GFA AIRWORTHINESS DIRECTIVE

SUBJECT: Inspection and modification of the tailplane locking mechanism.

DOCUMENTATION: Schempp-Hirth combined technical note: 278-36, 286-33, 295-26, 328-11, 798-3

HORIZONTAL TAILPLANE, ATTACHMENT AND CONTROL CONNECTION

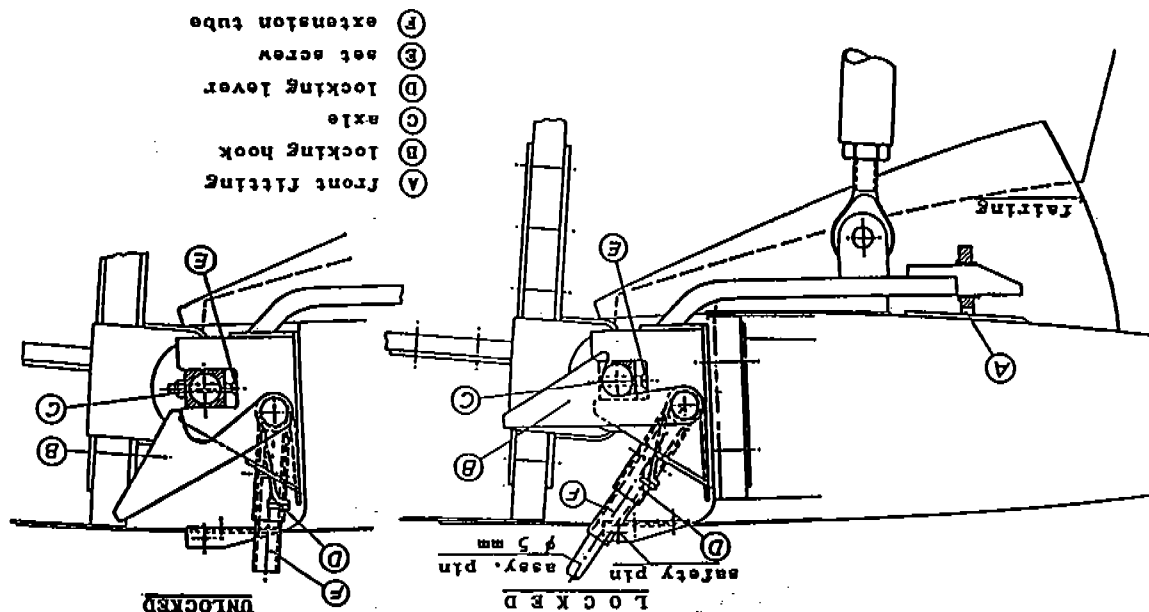
WORKING INSTRUCTIONS FOR INSTALLING THE SAFETY DEVICE FOR THE TAILPLANE LOCKING LEVER

1. Re-adjust set screws on tailplane attachment bracket such that there is no tangential play.

Note: Should it prove impossible to eliminate the play (move tips of tailplane back and forth), the tailplane attachment bracket with its locking hook (B) must be replaced.

2. Cement extension tube (F) into locking lever (C) and secure in position with the aid of a cotter pin 2 x 16 (DIN 94).

3. Fit angular metal fittings to tailplane and mark their position with the latter in place, locking lever (D) in rearward (locked) position and coving safety pin resting against the extension tube (F).

4. Remove tailplane and attach angular metal fittings as shown in the sketch.

5. Mount horizontal tailplane, secure it and check for full and free movement up to the stops.

SAFETY DEVICE FOR
LOCKING LEVER

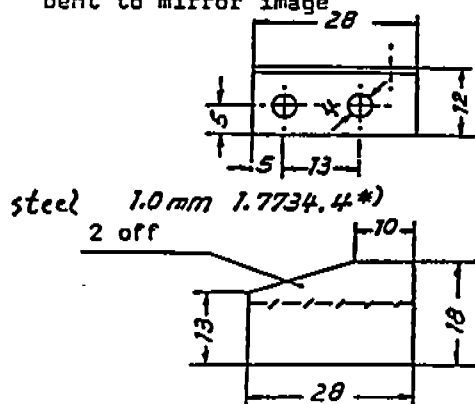
4 off flat head bolts M4x10 DIN 95-28
4 off washers 4.3 DIN 125-St
4 off Polystop nuts M4 DIN 985-8
